Responses to Examiner's Remarks in Detailed Action

Appl. No. 10/774,544
Response to Office Action of 2/24/05
Response Dated May 24, 2005

FIG. 1

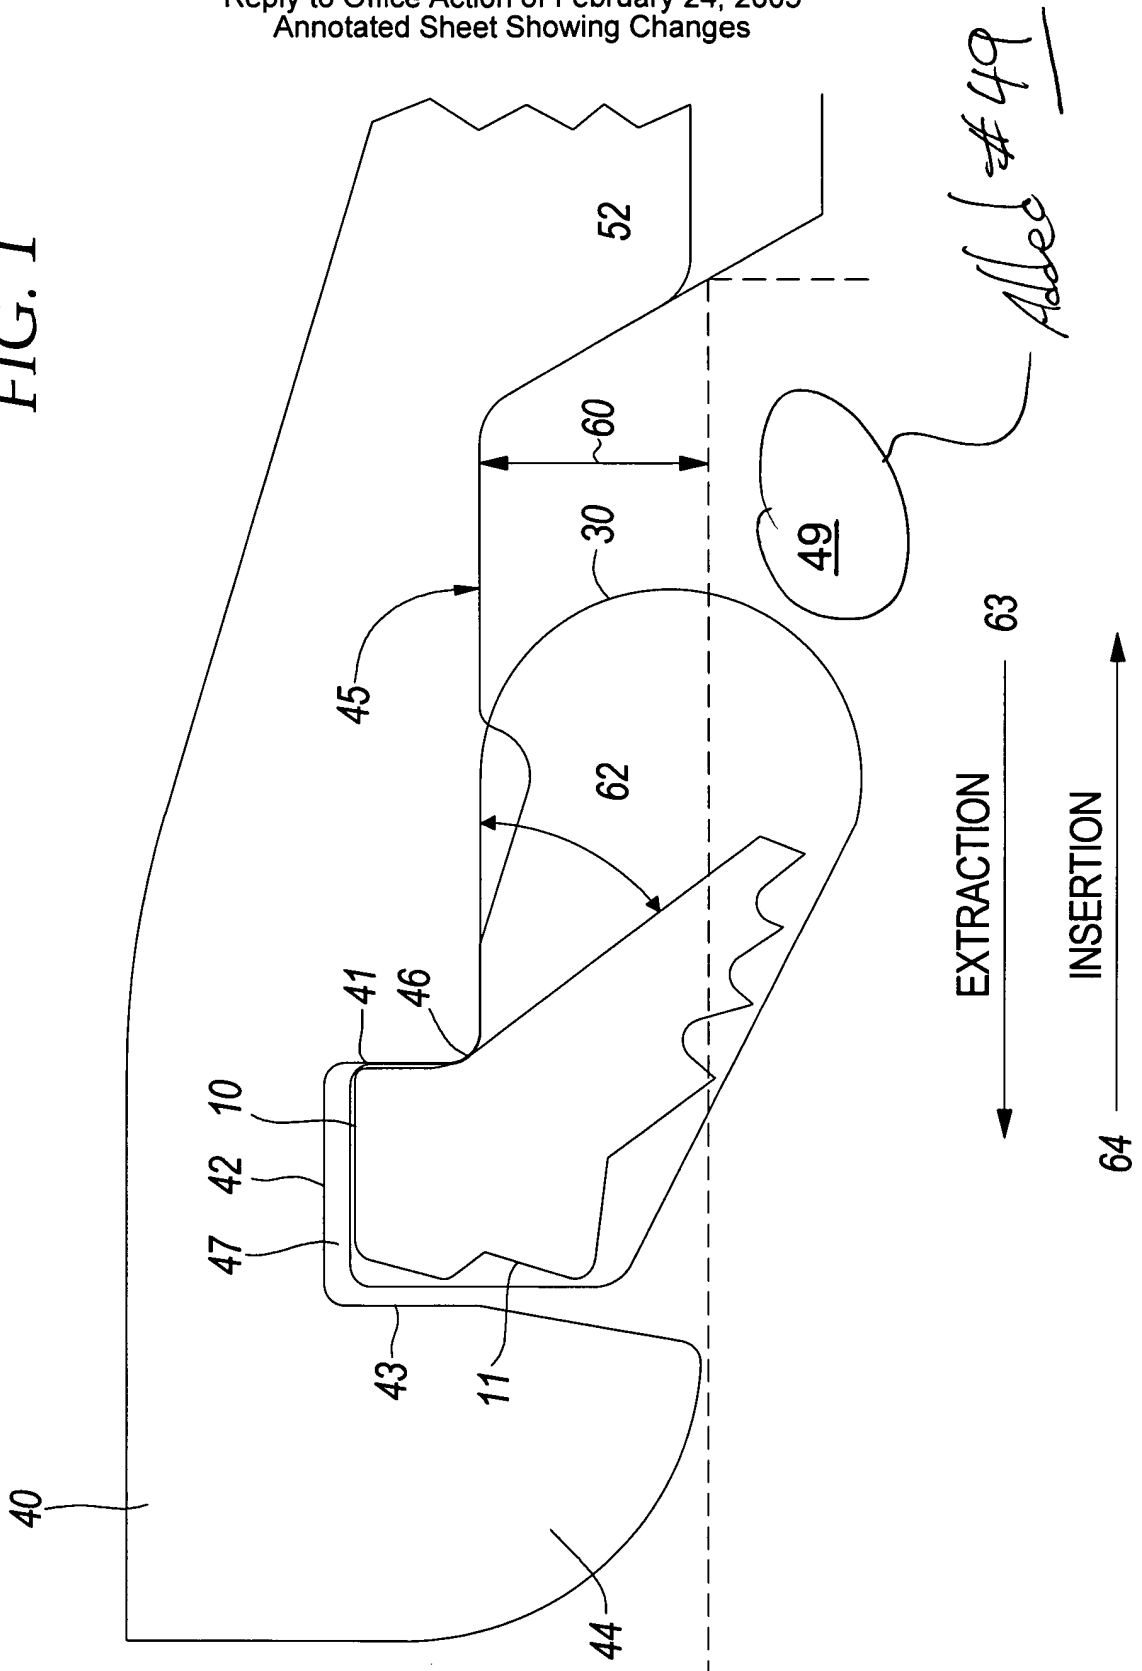
In response to Paragraph 2, the Applicant has (1) amended Figure 1 to include a reference numeral 49, designating the area of the cavity, and (2) amended Figure 2 to show the location of the forward brake 3. Such amendments are shown in the attached Replacement Sheets (Appendix A) and Annotated Sheets (Appendix B), and are believed to satisfy the requirements of the Examiner in Paragraph 2. If additional issues are discovered, Applicant invites a telephone call for the possibility of an examiner's amendment.

Figure 1: Reference numeral 49 has been added, shown in underline to indicate that the reference numeral refers to the area in which it is placed, pursuant to 37 C.F.R. 1.84. The Applicant thanks the Examiner for noting the omission of this figure. Reference numeral 40 has been relocated to help clarify that the bell 40 refers to the overall structure of this area of the female pipe, as distinguished from the bell lip 44, which refers to the interiorly extending structure of the bell 40.

FIG. 2

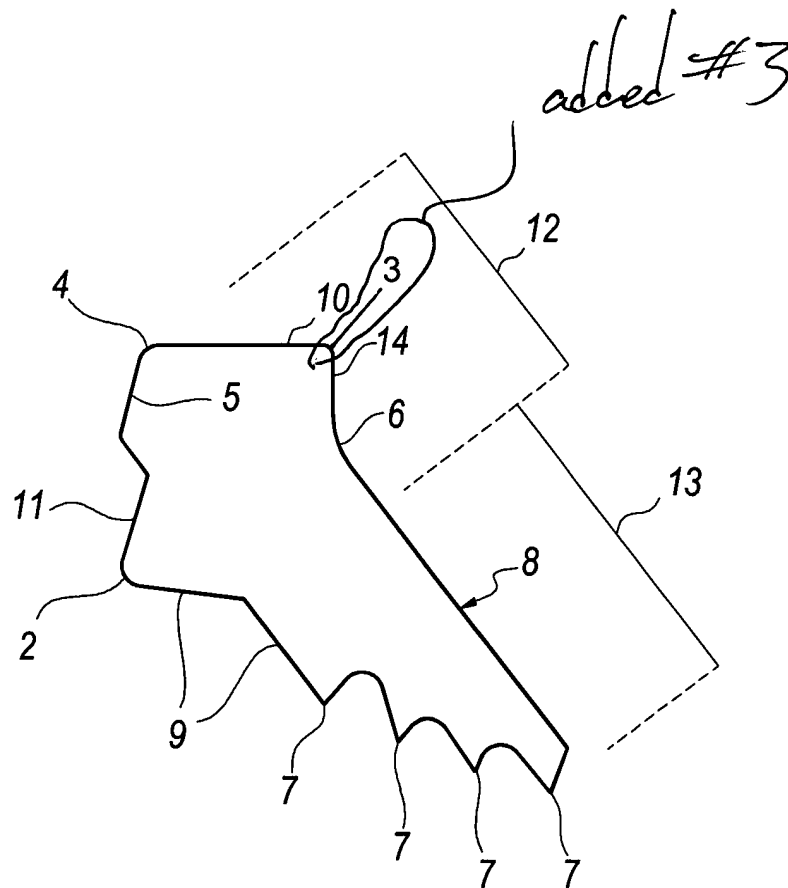
Figure 2: Reference numeral 3 has been added to designate the forward brake.
